Appendix S –  
Comments from Agencies and Tribes

From: Bethaney.Bacher-Gresock@dot.gov [mailto:Bethaney.Bacher-Gresock@dot.gov]  
Sent: Monday, February 13, 2012 12:11 PM  
To: Strength, Stephanie - RD, Washington, DC  
Subject: USDA - RUS DEIS for the CapX 2020 Hampton-LaCrosse 345-kV Transmission Line Proposal

We have received and reviewed the document entitled "Draft Environmental Impact Statement (DEIS) Financing Assistance for Proposed Hampton-Rochester-La Crosse 345 KV Transmission System Improvement Project" dated December 2011. As a cooperating agency, please consider the following general information concerning our regulatory program. Additional comments specific to the DEIS are also provided below.

Figure 1. Schematic portrayal of potential hazard of placing lines too near bird use areas and an example of using a nearby bluff to reduce collision risk (adapted from APLIC 1994).

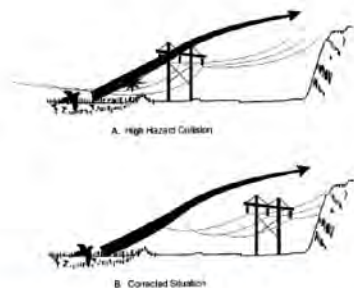
Reducing bird collisions is “more complex than simply installing diverters” on static (ground) wires (Stake 2009), but markers or diverters may reduce the number of birds killed or injured by about 75% (e.g., Avian Power Line Interaction Committee (APLIC) 1994; Barrientos et al. 2011; Brown & Drewien 1995; Savereno et al. 1996). Bird Flight™ Diverters and the FireFly are examples of two devices that may be especially effective at reducing collision risk (Fig. 2). The design or low statistical power of certain studies, few studies of some of the relatively new diverters, including the FireFly, and contradictory results among some studies limits our ability to draw strong inferences about the relative benefits of various types of markers, marker spacing, color, etc. (Avian Power Line Interaction Committee (APLIC) 1994; Barrientos et al. 2011; Murphy et al. 2009). Therefore, the best available scientific information should be reviewed and considered in light of the species in need of protection at a certain site before selecting and installing any marker or diverter. In addition, monitoring should be conducted to ensure that markers are performing as expected. Markers should be replaced if they are not performing as expected or if scientific evidence indicates that a more effective marking scheme is feasible.

Potential bird collision impacts are discussed in EIS Section 3.5.2.4 and measures to reduce impacts and other potential mitigation measures are discussed in Section 3.5.3.4. Sections 3.5.2.4 and 3.5.3.4 of the EIS has been expanded to incorporate information from those references provided in the comment that are not already included in the Draft EIS discussion.

Figure 3. Both the preferred and the alternative routes for the Hampton to North Rochester segment of the 345 kV line pass through the area where unrecorded population of the federally endangered Minnesota dwarf trout lily may occur where suitable habitat occurs on forested floodplains or slopes.

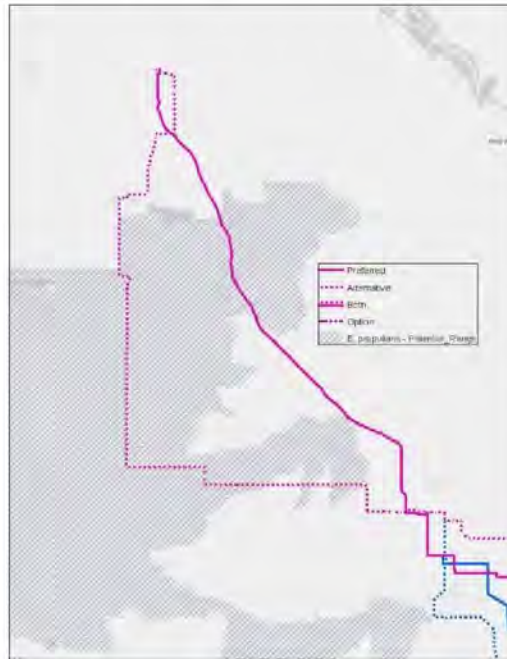
we recommend that the Minnesota Route Permit applicants conduct surveys for Minnesota dwarf trout lily within the species' potential range (Fig. 1) if the final selected route may affect "north-northwest or northeast-facing slopes dominated by maple-basswood stands and adjoining flood plains dominated by lowland hardwoods" (Sather 2009:2). Depending on the results of any surveys, USFWS may recommend that the applicants take certain steps to avoid, minimize, or mitigate adverse effects to the species.

The dwarf trout lily range map included with the comments has been added to Section 3.5.1.5 (as Figure 3-14).

Figure 4. Areas where the proposed Q1 - Highway 35 Route would deviate from running along the base of the bluffs and may pose an increased risk of collisions for birds.

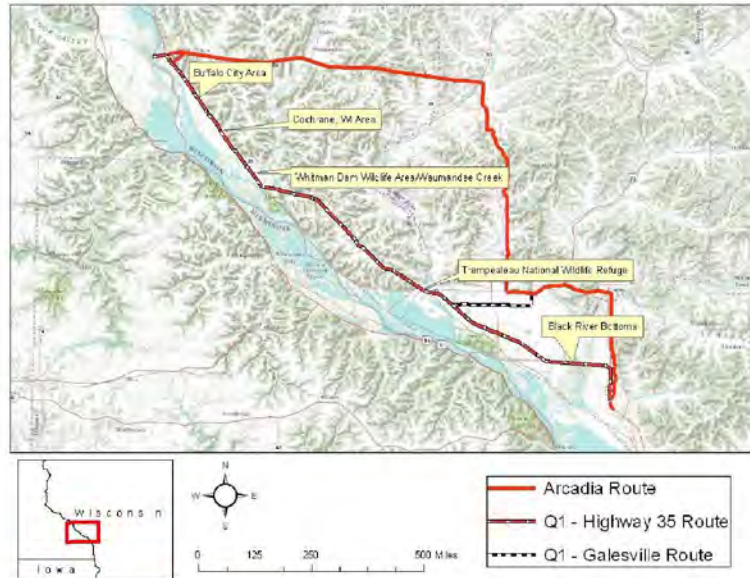
**F-004-012** | p. 259 – “*As shown in Figure 3-9, in the vicinity of Pool 5, the alignment that parallels the river (Q1) is adjacent to the bluff. The bluff is much higher than the river, and the birds flying over the line would be well above the power line elevation, in order to clear the bluff.*” There are sections of the proposed Q1 – Highway 35 route along Pool 5 that are not adjacent to the bluff and where birds may face the ‘high hazard’ conditions described above (Fig. 1). These sections include an area north of Buffalo City, WI, an area near Cochrane, WI, an area along upper Pool 5A near Whitman Dam Wildlife Area, Trempealeau National Wildlife Refuge, and the Black River bottoms (Fig. 4). Large numbers of Canada geese (*Branta canadensis*) and mallards (*Anas platyrhynchos*) inhabit the area near Buffalo City, WI and Cochrane, WI. Near Cochrane, the power line would be slightly less than one mile from the Spring Lake Closed Area, which is heavily used by waterfowl and north of Buffalo City the Q1-Highway 35 route would run between the Lizzy Pauls Pond portion of the refuge and the Mississippi River. Lizzy Pauls Pond is heavily used by Canada geese, which would fly to and from the river. Trempealeau National Wildlife Refuge is already mentioned in the DEIS (p. 214) as an area of global importance for birds and on p. 259 as an area of potential concern for bird collisions. A significant numbers of great blue herons (*Ardea herodias*) fly from the Mertes Slough heron/egret nesting colony to feed on Trempealeau National Wildlife Refuge. Depending on water levels, they sometimes fly across the proposed Q1-Highway 35 power line route to feed. The Black River bottoms is mentioned as containing important bird habitat, but should also be mentioned as an area where the power line may pose significant risk for bird collisions. In years of good acorn production, for example, large numbers of wood ducks inhabit the Black River bottoms during fall migration.

The information provided has been added to Section 3.5.2.4 of the EIS.

Figure 5. Section of the Q1 – Highway 35 Route that would run for about five miles away from the bluffs and near two wetland complexes, including the Whitman Dam Wildlife Area.

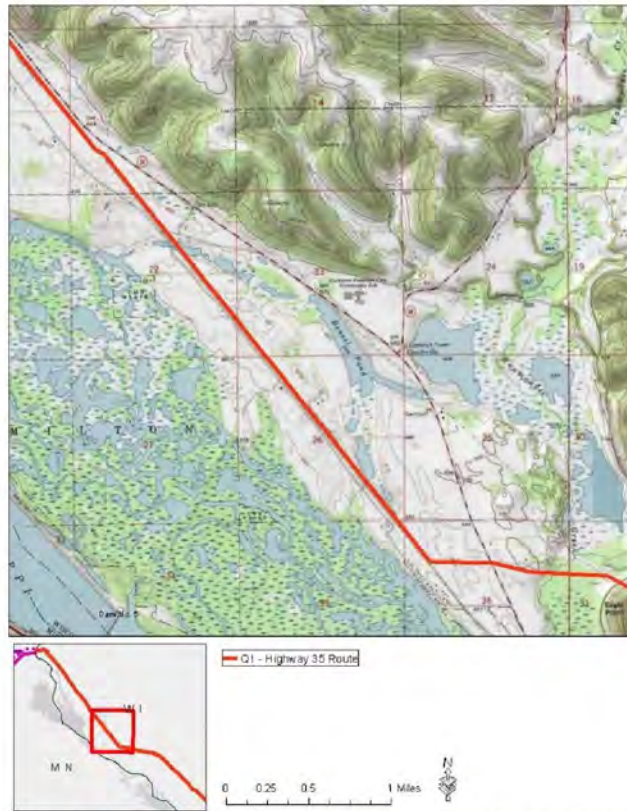
p. 259 – “At Pool 5A, the alignment is approximately two miles from the river, in the Blufflands (Figure 3-10).” In the uppermost section of Pool 5A, a five-mile-long section of the Q1 – Highway 35 route would deviate from the bluffs and run along a large wetland complex that includes the Whitman Dam Wildlife Area and the extensive wetland complex near the mouth of Waumandee Creek (Fig. 3). This area should be analyzed in greater detail in the final EIS to determine whether significant bird traffic may cross the proposed power line route. This analysis should describe the species that may cross the route daily during at least one season and should determine whether there are factors present that may mitigate the risk of bird collisions in all or part of this reach (e.g., adjacent trees that would extend at least to the top of the power lines).

The boundaries of Whitman Dam Wildlife Area on the referenced figures (now Figures 3-10 and 3-11) have been highlighted and a reference to this area has been added to the text. The requested analysis has been added to Section 3.5.2.4, using information from the Wisconsin DNR, the Wisconsin Bird Conservation Initiative, the Wisconsin Final EIS for the project (prepared jointly by the Wisconsin DNR and the Wisconsin PSC), and USFWS bird monitoring data.
